ADDENDUM

Minerals Reclamation Permit Annual Report Permit Number M-1994-117

Prepared by: Avrom E. Howard, MSc, PGeo
Date: August 25, 2020

**E-3 MINE RECLAMATION PLAN
 COLORADO MILLING CO.- GOLD HILL MILL WATERLINE
 LOCATED IN SECTIONS 2/11/12, T-1-N, R-72-W OF THE SIXTH P.M.,
 COUNTY OF BOULDER, STATE OF COLORADO**

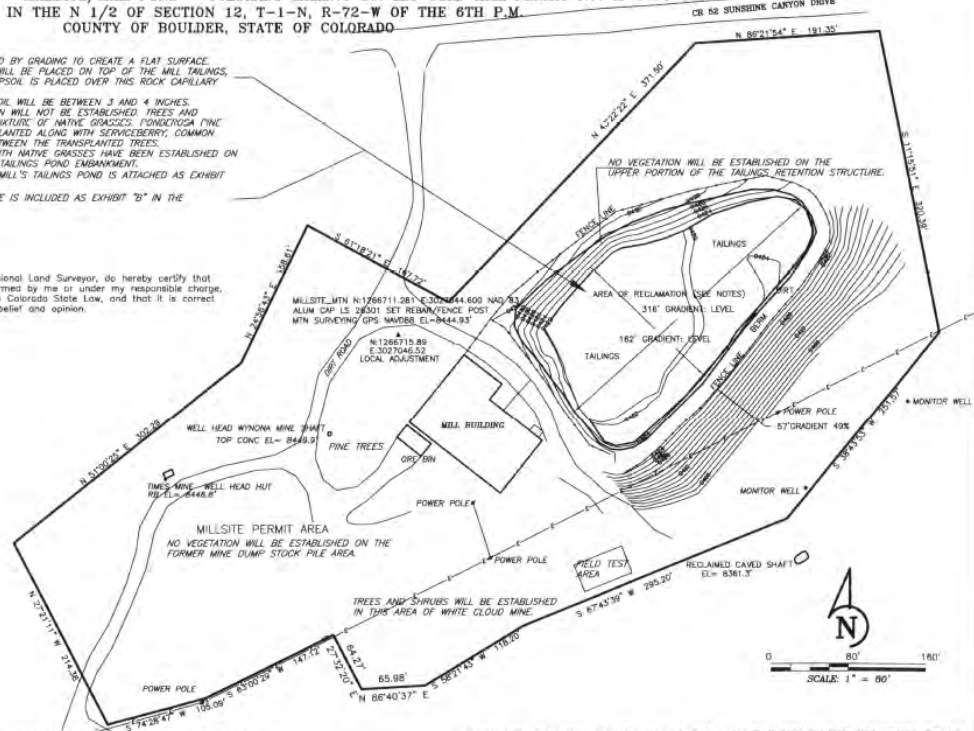
This item requires the submission of map(s) that “accurately depict the permit boundary, current affected area boundary and location of the acreages specified in items 8, 12 and 15. Please see the maps on the following pages.
